POWER PLANT - ENGINE - INCORPORATION OF REROUTING AND MODIFICATION REQUIREMENTS FOR THE
EEC FAN HARNESS - CATEGORY CODE 5 - MOD.ENG-71-0050

V2500-ENG-71-0050

EEC Fan Harness clipping detail - Before alteration
Fig.2 (Sheet 1 of 2)

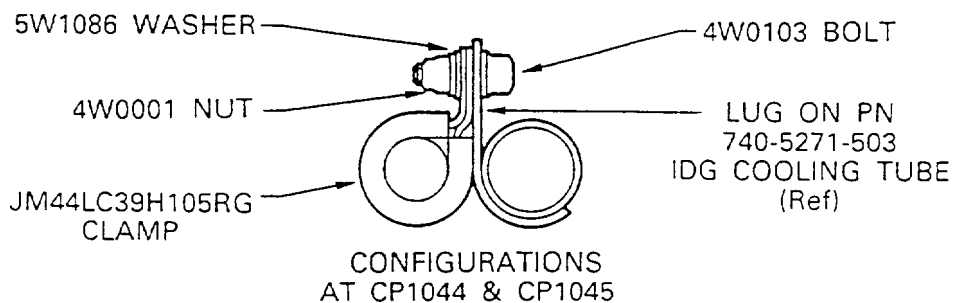
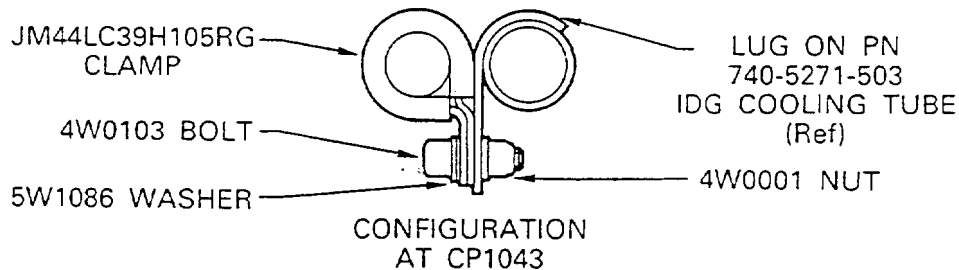
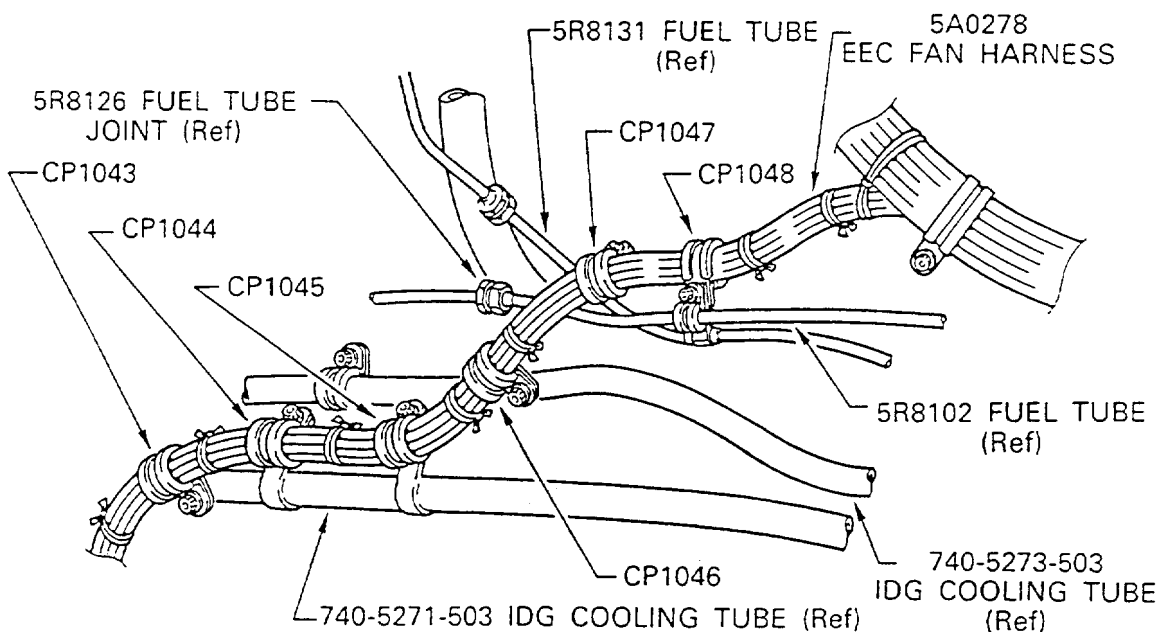
Chafing to the FMU Harness (which breaks out of the EEC Fan Harness (A/O), may occur because of the close proximity to a wirelocked tube joint between CP1046 and CP1047. The FMU Harness may also contact the No.4 Fan Cowl Latch during the opening of the Fan Cowl Doors.

- (1) The changes introduced by this Service Bulletin are as follows:
 - (a) The existing CP1045 which safeties the FMU Harness and the IDG Cooling Tube has been deleted to replace with CP1095. (See Figures 2 and 4).
 - (b) A new CP1095 is introduced to reroute the Harness. (See Figure 4).
 - (c) The existing CP1047 which safeties the Harness and the Fuel Tube has been deleted to reroute the Harness. (See Figure 2 and 4).
 - (d) The existing CP1048 which safeties the Harness and the Fuel Tubes has been rearranged to get the clearance between the Harness and the Fuel Tube Joint. (See Figures 2 and 4).
 - (e) The Spiral Wrapping is installed on the Harness between CP1043 and CP1048 to improve Harness durability. (See Figure 3).
- (2) The existing EEC Fan Harness can be reworked to a new configuration. (See Figure 3).

- (b) At each CP1043, CP1044 and CP1045, remove PN 4W0001 Nut, PN 5W1086, Washer, PN 4W0103, Bolt and PN JM44LC39H105RG, Clamp from PN 5A0278, EEC Fan Harness and each Lug on PN 740-5271-503, IDG Cooling Tube

- (c) At CP1046, remove PN 4W0001, Nut, PN 5W1086, Washer, PN JM44LC39H105RG, Clamp and PN 4W0103, Bolt from PN 5A0278 EEC Fan Harness and the Lug on PN 740-5273-503, IDG Cooling Tube

- (d) At CP1047, remove PN 4W0001, Nut, PN 5W1086, Washer, PN JM44LC39H105RG, Clamp and PN 4W0103, Bolt from PN 5A0278 EEC Fan Harness and the Lug on PN 5R8131 Fuel Tube

- (e) At CP1048, remove PN 4W0001, Nut, two PN 5W1086, Washers PN 4W0105, Bolt, PN JM44LC39H105RG, Clamp and PN 400WSS4, Adel Clamp, from PN 5A0278, EEC Fan Harness, PN 5R8102, Fuel Tube and the Lug on PN 5R8131 Fuel Tube Refer to Figure 2

Rework of the EEC Fan Harness
Fig.3 (Sheet 1 of 5)

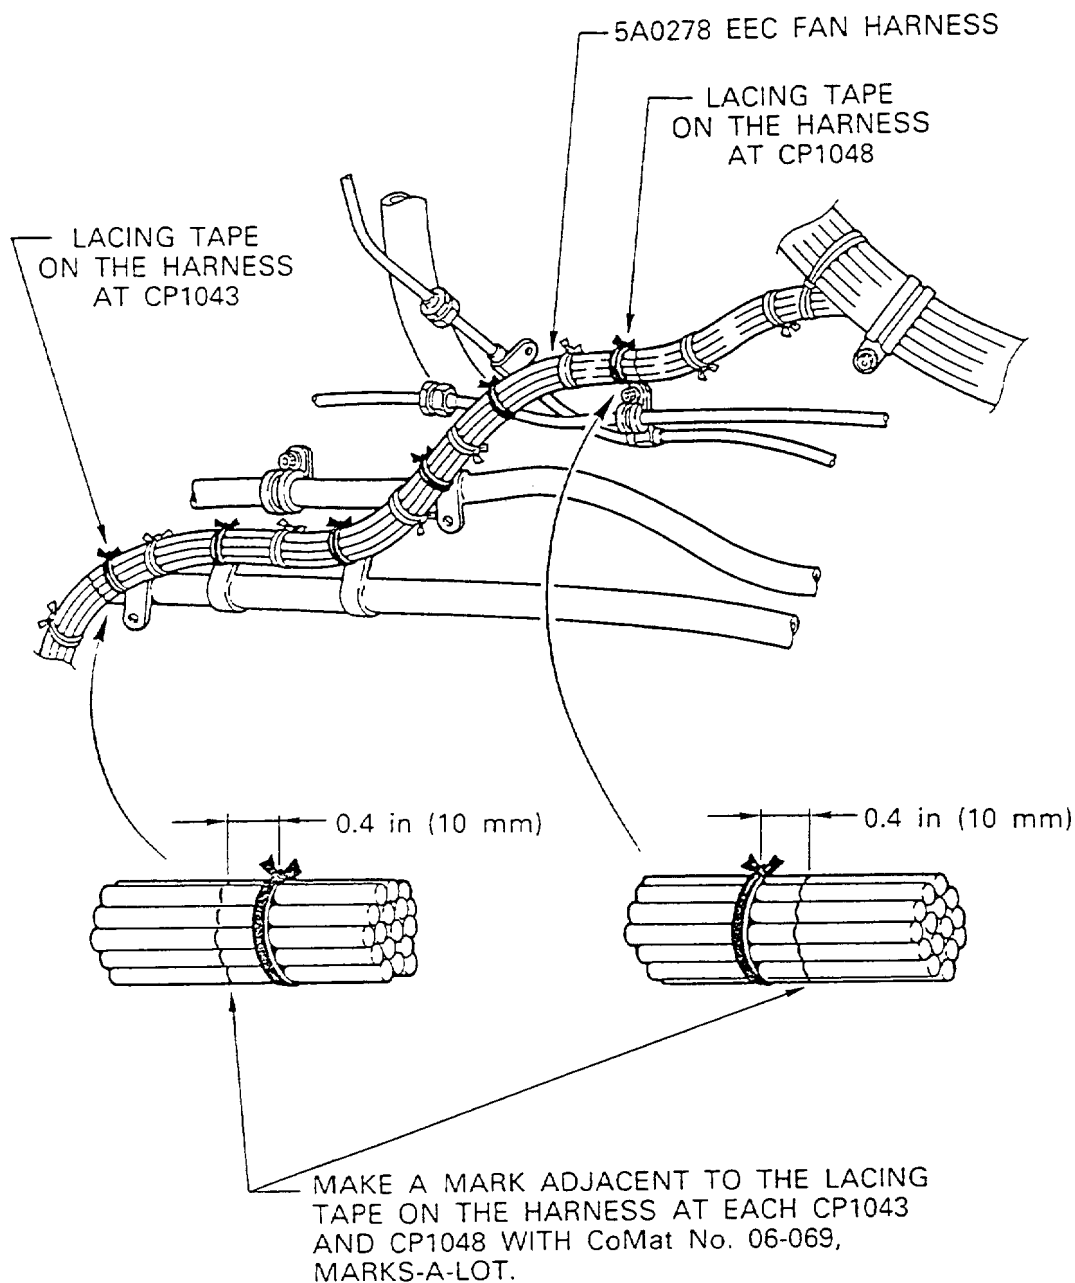
- (f) At each CP1043 and CP1048, make a mark on PN 5A0278, EEC Fan Harness with CoMat No.06-069, Marks-A-Lot to identify the area to be reworked Refer to Figure 3, Sheet 1

- Refer to Figure 2, Sheet 2
- (d) At each CP1043 and CP1048, make a mark on PN 5A0278, EEC Fan Harness with CoMat No.06-069, Marks-A-Lot to identify the area to be reworked

Rework of the EEC Fan Harness
Fig.3 (Sheet 2 of 5)

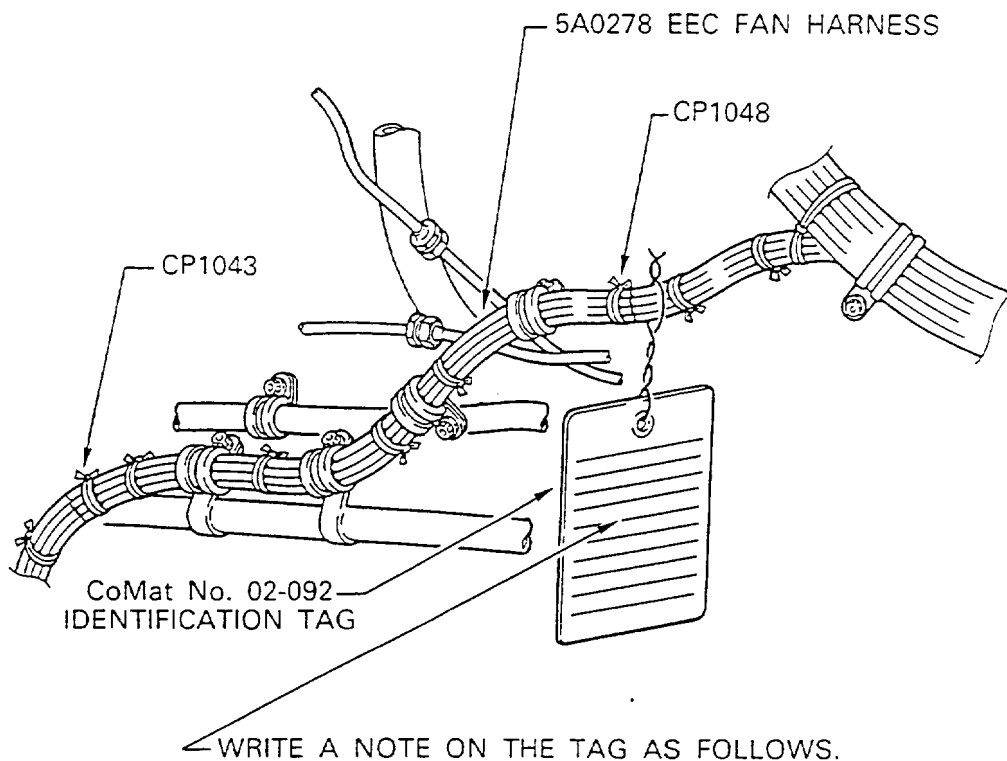
- 1 THIS TAG SHOWS THE AREA
BETWEEN TWO MARKS TO BE
REWORKED.
- 2 DO NOT REMOVE THIS TAG UNTIL
THE MODIFICATION BY THIS S.B.
IS COMPLETED.
- 3 SEND THE HARNESS TO A SHOP
WHERE IT IS TO BE REWORKED.

| (f) Install CoMat No.02-092, Identification Tag on PN 5A0278, EEC Fan Harness near CP1048 to identify the area to be reworked by this Service Bulletin | Refer to Figure 3, Sheet 2 |

Rework of the EEC Fan Harness
Fig.3 (Sheet 3 of 5)

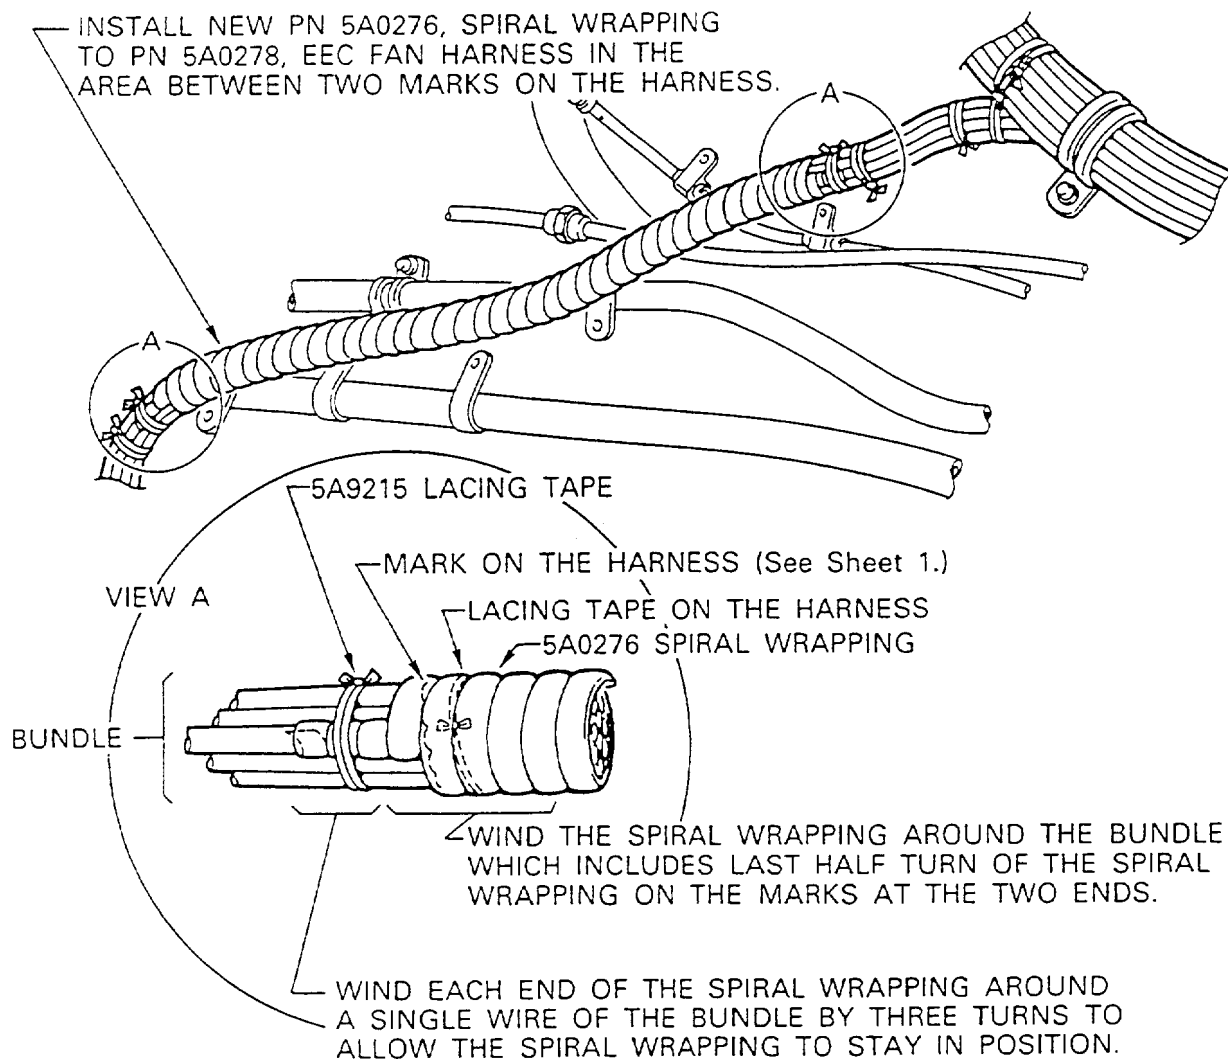
CUT THE UNNECESSARY ENDS OF THE SPIRAL WRAPPING.
REMOVE THE SHARP CORNERS.

SAFETY THE END OF THE SPIRAL WRAPPING BETWEEN
THE SINGLE WIRE AND THE REMAINING WIRES OF THE
BUNDLE.

TIGHTLY FASTEN THE ENDS OF THE SPIRAL WRAPPING
AND THE BUNDLE TOGETHER WITH PN 5A9215, LACING
TAPE. (See Sheet 4.)

- (g) Install PN 5A0276, Spiral Wrapping between two marks on PN 5A0278, EEC Fan Harness and fasten each end with PN 5A9215, Lacing Tape Refer to Figure 3, Sheet 3 and Sheet 4

Rework of the EEC Fan Harness
Fig.3 (Sheet 4 of 5)

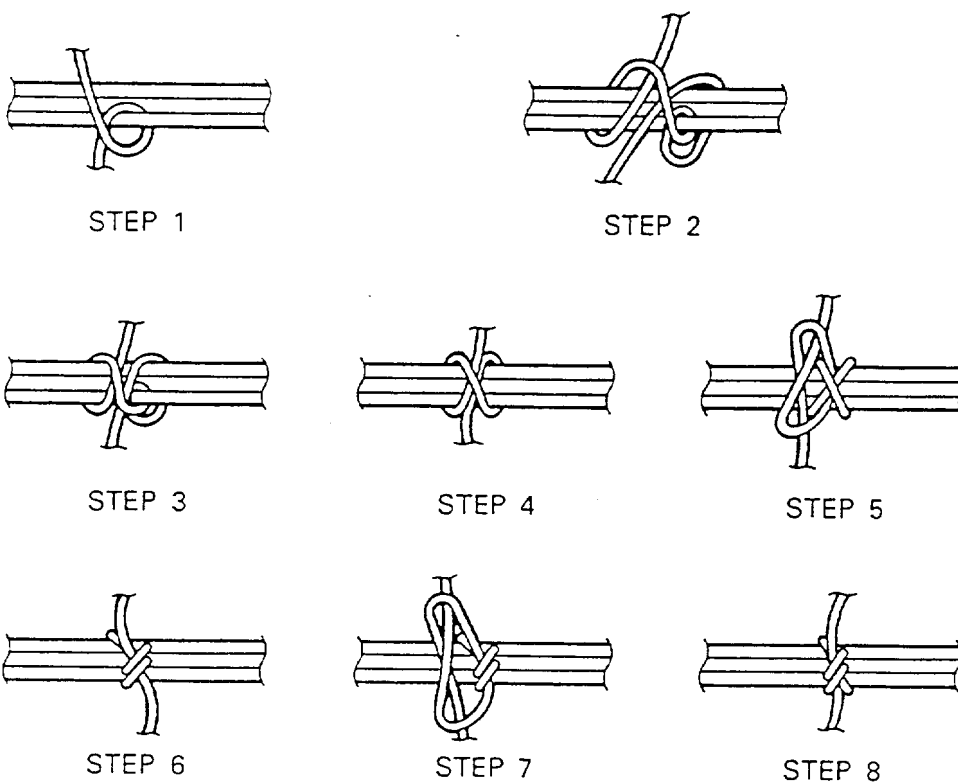
THIS ILLUSTRATION SHOWS A STEP-BY-STEP PROCEDURE HOW TO FASTEN EACH END OF THE SPIRAL WRAPPING AND THE BUNDLE TOGETHER WITH THE LACING TAPE.

NOTE: REQUIRED QUANTITY OF THE LACING TAPE IS 23.62 in (600 mm) LONG TO FASTEN EACH END OF THE SPIRAL WRAPPING AND THE BUNDLE.

Rework of the EEC Fan Harness
Fig.3 (Sheet 5 of 5)

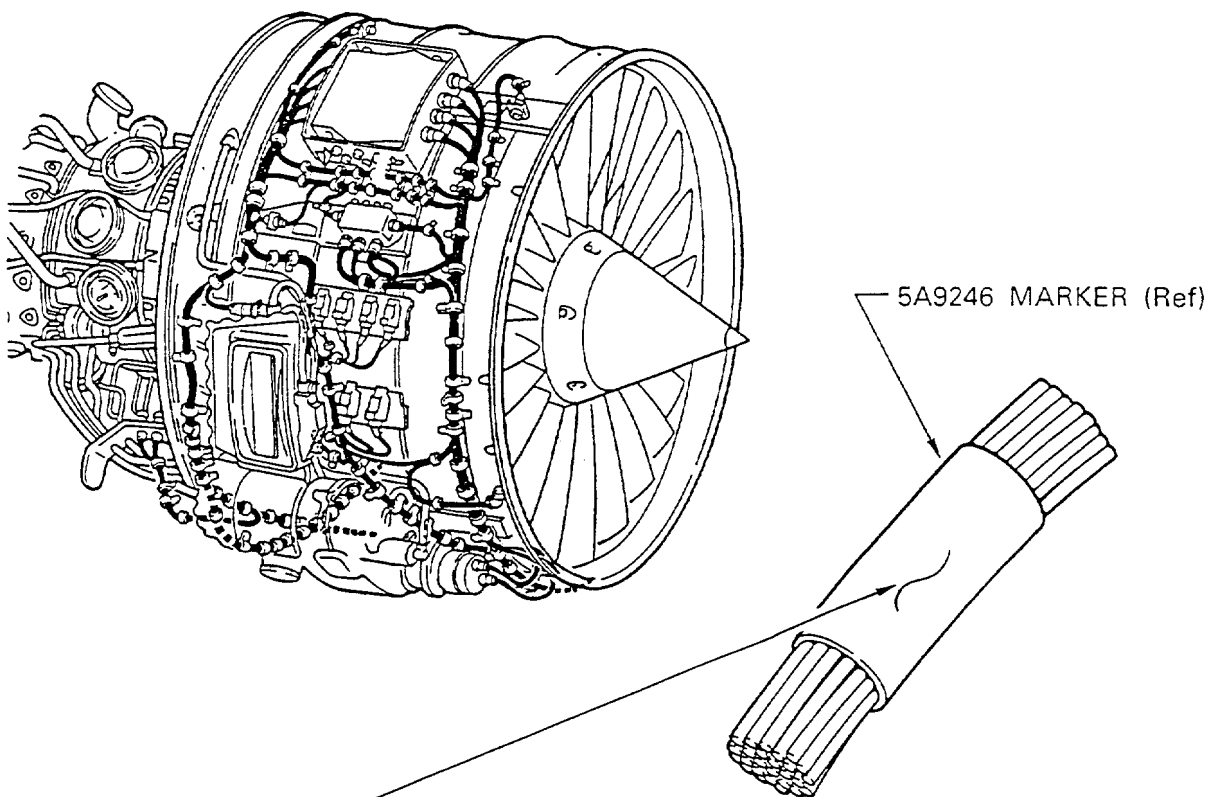
ERASE THE EXISTING PN 5A0278
ON PN 5A9246, MARKER WITH
CoMat No. 05-019, WATERPROOF
ABRASIVE PAPER.

MAKE A NEW PN 5A0356 ON PN
5A9246, MARKER WITH THE
MATTHEWS WHITE M-145 INK AND
No.7 INK THINNER.

- (h) Renumber by hand writing on PN 5A9246, Marker on the EEC Fan Harness Refer to Figure 3, Sheet 5
- (i) At each CP1043 and CP1044, install new PN JM44LC39H106RG, Clamp, PN 4W0103, Bolt, PN 5W1086, Washer and PN 4W0001, Nut to new PN 5A0356, EEC Fan Harness and PN 740-5271-503, IDG Cooling Tube Refer to Figure 4
